# Warakirri College Modification 1

State Significant Development Modification Assessment  
(SSD-10420-MOD 1)

Title: Warakirri College MOD 1 - Amendments to floor levels

Subtitle: Modification to amend floor Reduced Levels and minor alterations.

**Figure 4 |** Comparison of approved (above) and proposed (below) basement depth (Source: Applicant's Modification Report, 2022)

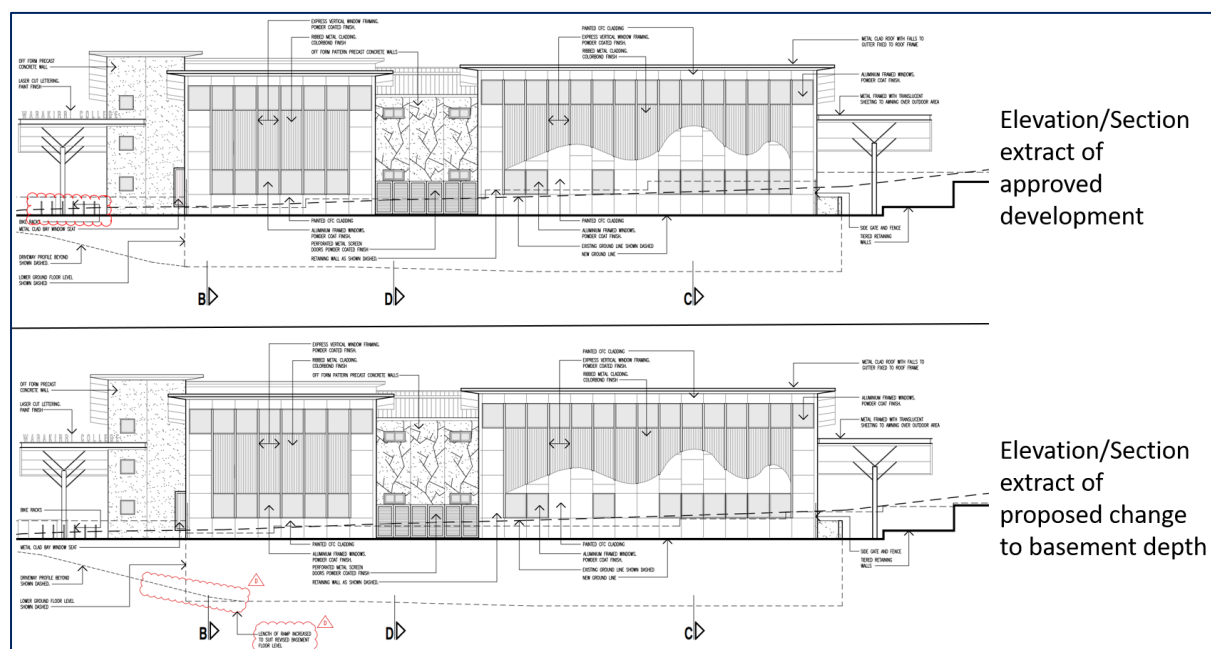
The Applicant identified the survey error (discussed above) following the excavation of the basement. A correction has been made to the design plans to compensate for the survey error, which has resulted in the basement floor being 330mm lower instead of 330mm higher up. The result is that

there was an additional 660mm of excavation (330mm x 2) leaving the basement floor level 660mm deeper relative to the site's ground level. In addition, the RL of the Ground Floor has been reduced by 60mm relative to site ground level shifting the entire building envelope lower by 60mm relative to ground level. These changes are shown in **Figure 4** below.

The survey error discussed in **Section 2** was discovered following the excavation of the basement. A correction was made to the design plans intended to compensate for the survey error. In a compounding error, there was an additional 660mm of excavation leaving the basement floor level 660mm deeper relative to the site's ground level.

The result of the above error and miscalculation is the construction of a basement with a floor to floor level of 3.6m instead of the 3m that was approved (**Figure 4**). However, as the error occurred during excavation, the additional depth of the basement is contained below ground level, and not visible externally. The Applicant has adjusted the access to the basement to allow for the extra depth, and has been done so without impacting on the access and parking arrangement of the basement. Stair and lift accesses have also been adjusted without impacting on the footprint of the building.

Given the above, The Department considers that there are no additional impacts created by the proposal as a result of the increase in the depth of the basement and that this modification is acceptable.

**Figure 5 |** Existing (left) and proposed (right) lift core and basement stairs (Source: Applicant's Modification Report, 2022)

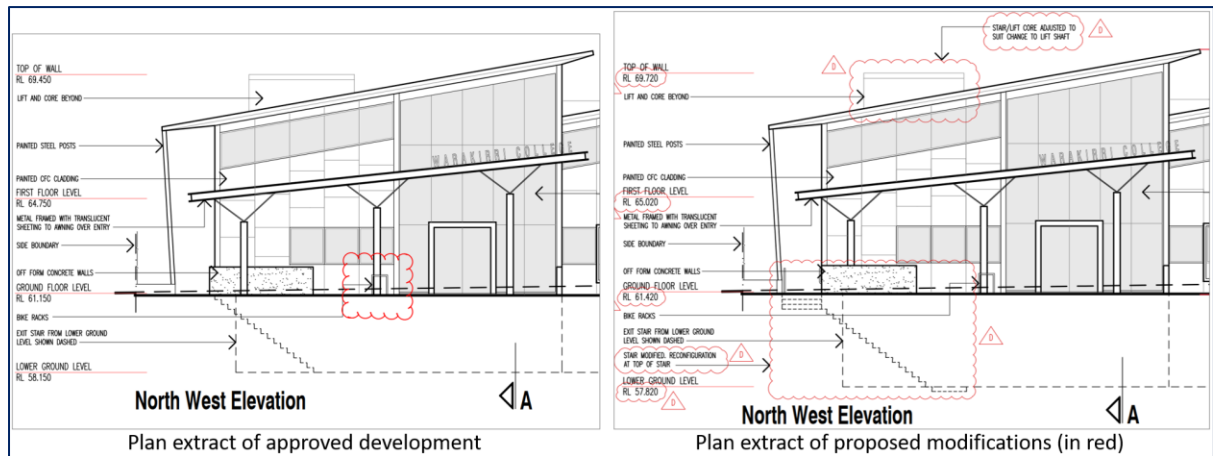
This modification seeks approval for the use of the basement which has been built 660mm deeper relative to ground level and with a floor to floor height of 3.6m rather than 3m as approved under SSD-10420. This, combined with a minor reduction in height of the structure due to a lowering of the Ground Floor by 60mm requires modifications to the stairs and lift core that are necessary to service the basement level.

Issue	Findings	Recommendations
<b>Vertical Circulation</b>	The modifications to the RLs within the building and the alteration to the basement result in a requirement to change the layout of the internal and external stairs, and to change the lift overrun. There would be minimal impacts on the appearance of the building with the only change being a reduction in the width of the lift overrun. This overrun remains the same height as approved and remains positioned below the top of the pitched roof of the building.	The Department considers the modifications to the lift core and vertical circulation to be satisfactory, and no additional conditions are required.
<b>Internal layout changes</b>	The Applicant has stated the proposed modifications to internal joinery and partitions have been designed with further input from Warakirri College to better suit the school's needs, make more efficient use of the approved internal space and improve staff supervision of students ( <b>Figures 6 and 7</b> ). These modifications do not alter the sizes of classrooms, external appearance. The student and staff numbers as originally approved.	The Department considers the modifications to the internal layout to be satisfactory, and no additional conditions are required.

**Figure 7 |** Approved (above) and proposed (below) Level 1 layout (Source: Applicant's Modification Report, 2022)

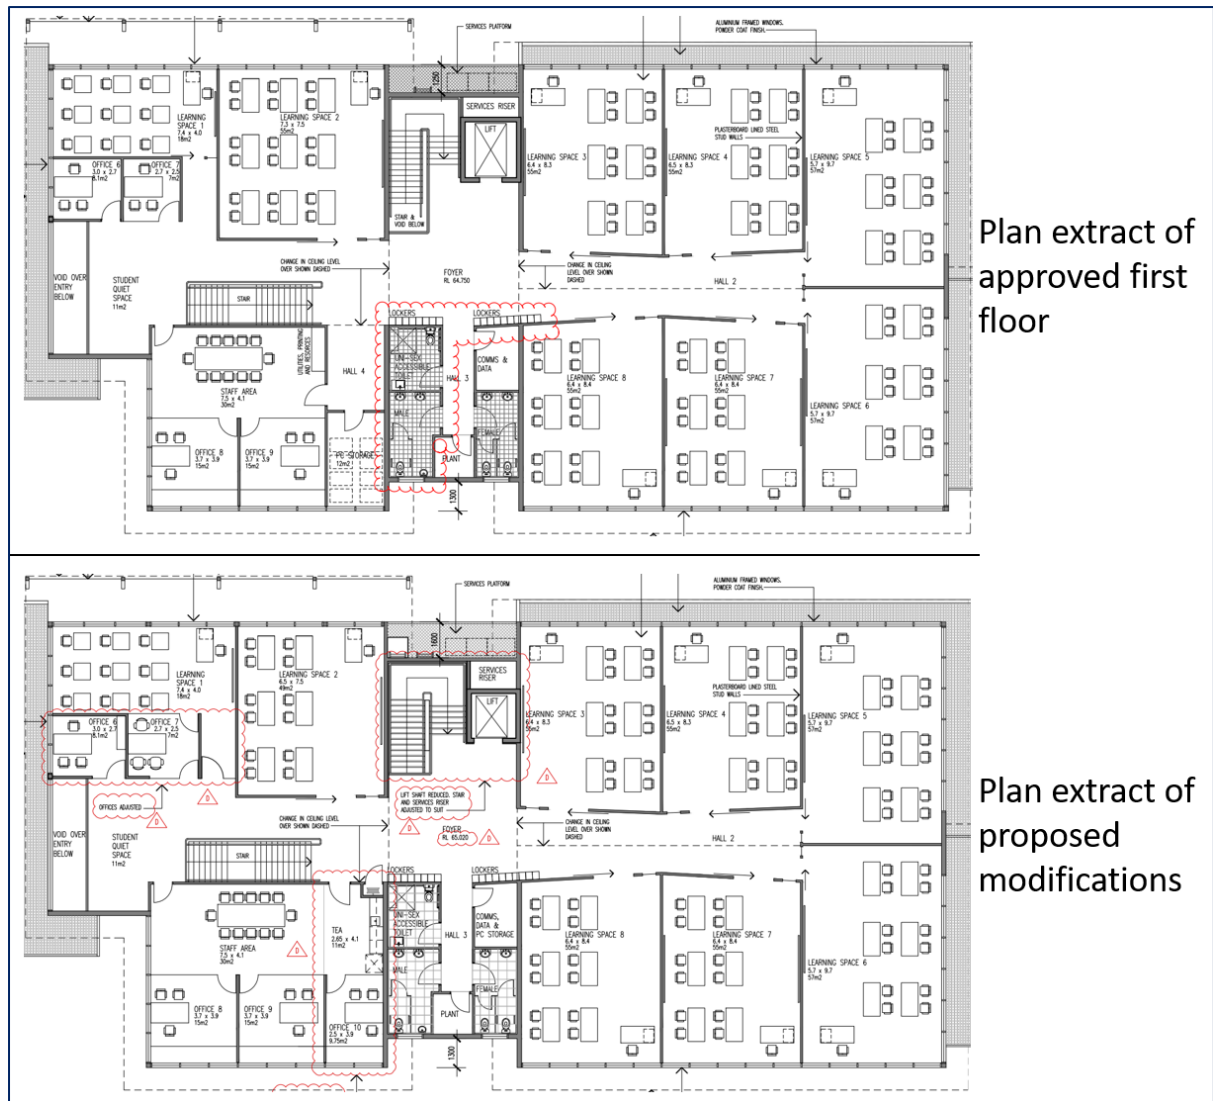
This modification application also seeks approval to make minor changes to the layout of Ground Floor and Level 1 offices, meeting rooms and tea-room facilities including the rearrangement of joinery. The Applicant has advised that the modifications would make more efficient use of the approved internal space and improve staff supervision of students. These modifications do not alter the sizes of classrooms, the student or staff populations, the approved gross floor area or have any external impacts.

**Figure 8 |** Approved (left) and proposed (right) external garden area (Source: Applicant's Modification Report, 2022)

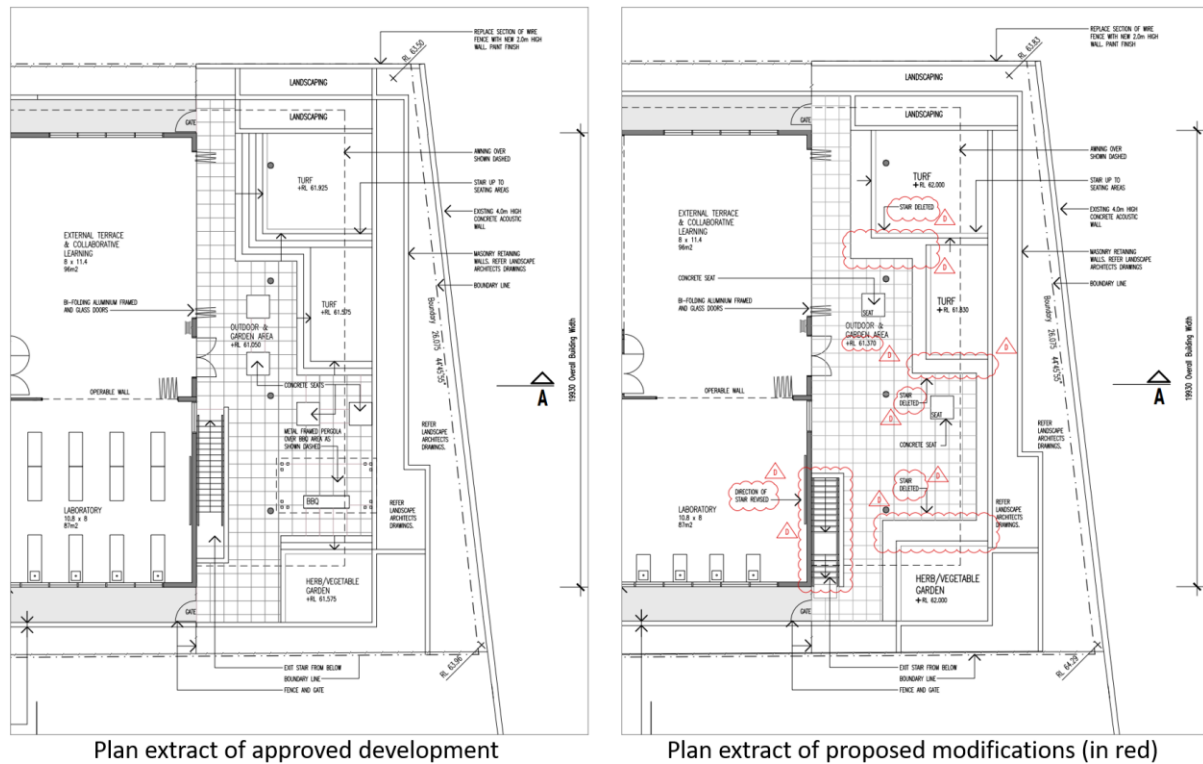
The modification also seeks to amend the outdoor stairs to turf areas to seating. The Applicant has advised that the proposed change is more attuned to how Warakirri anticipates student interaction with the space.

<b>Garden layout changes</b>	The modification seeks to remove the stairs to the turf areas and replace them with seating ( <b>Figure 8</b> ), which the Applicant states is more appropriate for the Warakirri students. The change would be minor, not visible from the public domain, and would maintain the approved level of outdoor amenity space.	The Department considers the modifications to the garden layout to be satisfactory. The modification would maintain appropriate amenity for the students in the future, and no additional conditions are required.
